Palo Verde Nuclear
Generating Station

**Subject: Palo Verde Nuclear Generating Station (PVNGS) Unit 1
Docket No. STN 50-528
License No. NPF-41
Response to NRC Draft Request for Additional Information 2010
Steam Generator Tube Inspections**

**Response to Draft Request for Additional Information
Unit 1 2010 Steam Generator Tube Inspections**

Figure 1
View of Patch Plate to Lug Weld Crack in RSG 21 at 90° Handhole Hot Leg Side

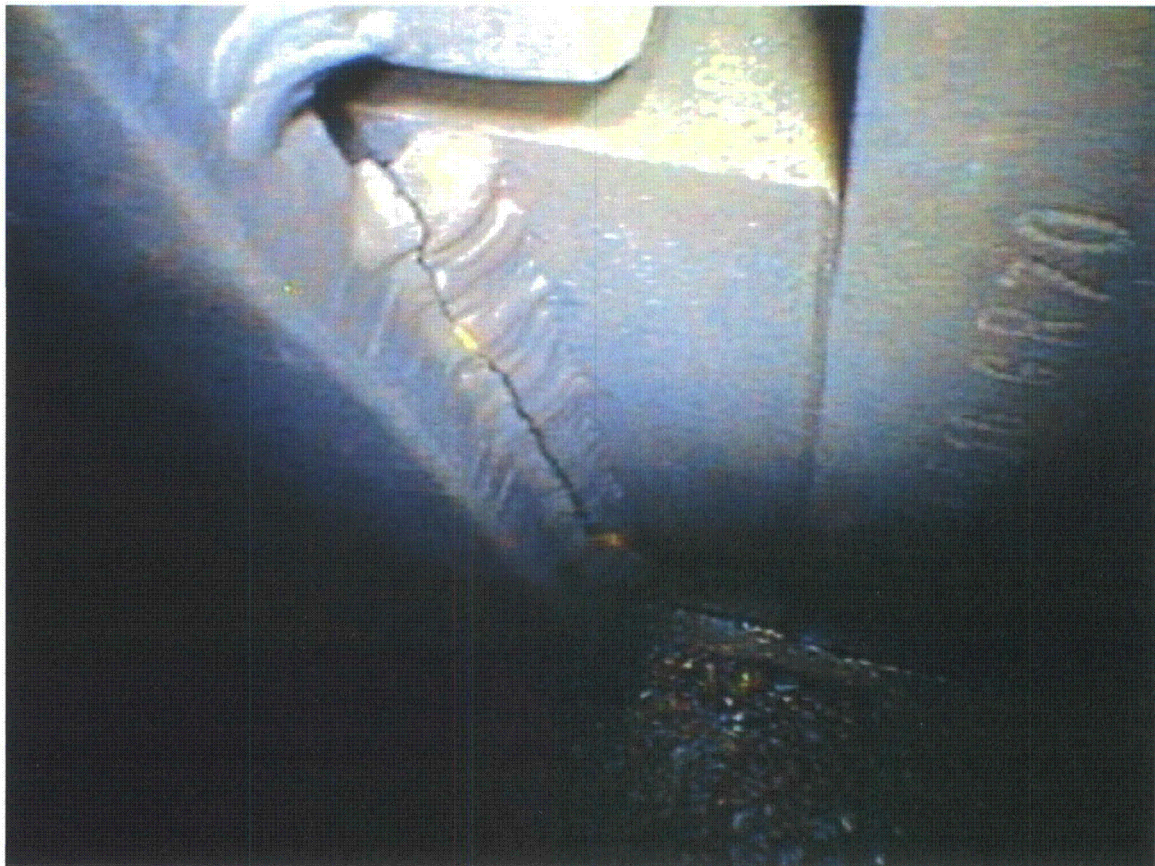
APS indicated that the scope of the foreign objects search and retrieval (FOSAR) effort included an inspection of the blowdown patch plate welds and that the inspections confirmed that all four patch plates (two per SG) were cracked similar to what was found in the Unit 2 SGs. Additionally, APS stated that the patch plate to lug weld was completely compromised and the patch plate to divider plate welds were completely intact. Please provide a description of the blowdown plate assembly, as well as a more complete description of the cracking found in the blowdown patch plate welds. Please summarize the basis of the conclusion that the cracking will not affect the functionality of the blowdown patch plates and that the probability of loose parts being formed is remote. Please describe any long term follow up actions planned to confirm the conclusions.

During Foreign Object Search and Retrieval (FOSAR) on the secondary side of the PVNGS Unit 2 replacement steam generators (RSGs) during the 15th refueling outage in Unit 2 (U2R15), cracked welds were observed on the (blowdown duct) patch plates, which are located on the secondary divider plate assembly near the 90-degree and 270-degree handholes (See Figures 1 and 2). Similar cracks were confirmed to exist on the twelve blowdown duct patch plates in each of the six RSGs. This condition is documented in the PVNGS corrective action program (Condition Report / Disposition Request (CRDR) 3395100).

The patch plate is designed to minimize the amount of feedwater that can exit the preheater region of the steam generator and does not provide structural support to any steam generator component. As long as it is free to move with the divider plate, it has no significant loads on it and the remaining weld is sufficient to hold it in place. As a result, it will continue to perform its design function and no actions are required to remediate this condition.

Another issue associated with the cracked weld is the potential for loose parts to be generated. An analysis has been performed to demonstrate that the remaining weld is structurally adequate to retain the plate in its design configuration in the worst case flow conditions. As a result, there are no concerns that the patch plate itself could become a loose part. A calculation was prepared by Westinghouse engineering to confirm this conclusion.

A review of Figures 1 and 2 shows the cracked weld metal remains attached to either the patch plate or the lug at every location except at the bottom. At this location there is a small section of the weld that is attached only to the patch plate. A close review of

where the cracked weld remains attached to the lug and patch plate does not show any indication of cracking or any other indication that it would become loose. This has been verified on all 12 patch plates at PVNGS. Since the crack has relieved any significant loadings on the weld, the likelihood that a piece would fall off is remote. As a result, there is a minimal risk that the cracked weld could cause a loose part that could affect the structural or leakage integrity of the tubes.

To confirm these conclusions, APS will inspect the patch plates whenever a top of tubesheet FOSAR is performed. These inspections will examine the remaining welds and verify they are intact and that the cracked welds are not disintegrating (chipping away) or forming a loose parts concern.
